October 2, 1998

RE: DRAINAGE PLAN FOR COVERED PARKING AT CAMINO REAL APARTMENTS  
(~~A14-D48~~) ENGINEER'S STAMP DATED 9/30/98

## COMINO REAL APARTMENTS COVERED PARKING GRADING PLAN

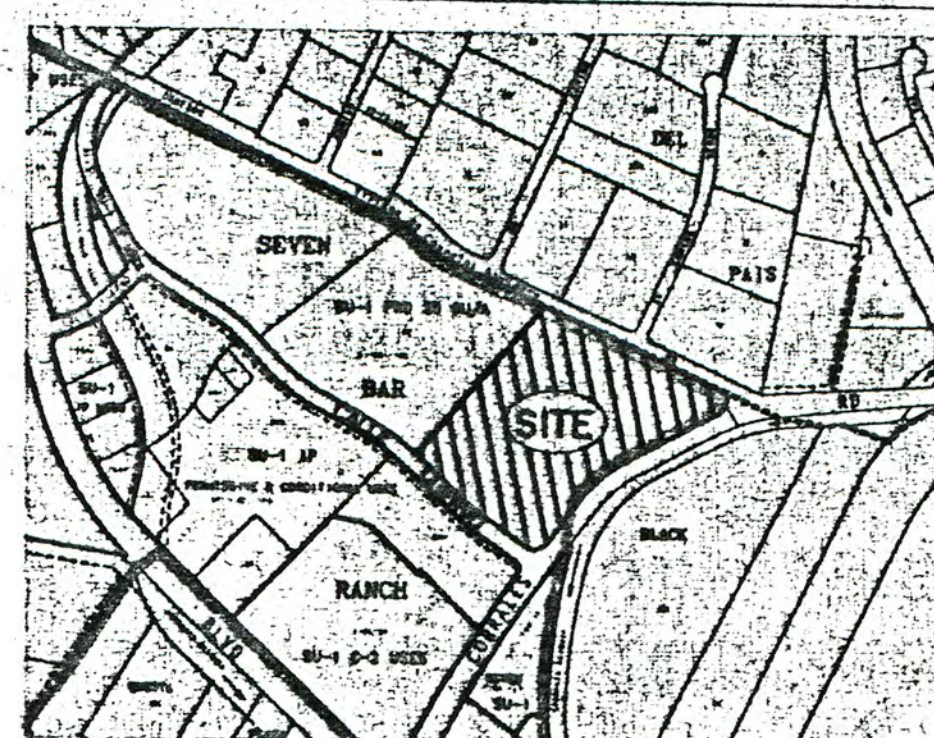
Based on the information provided on your October 1, 1998 submittal, the above referenced site is approved Building Permit .

Please attach a copy of this approved plan to the construction sets prior to sign-off by Hydrology.

Also, Prior to Certificate of Occupancy release, Engineer Certification per the DPM checklist will be required.
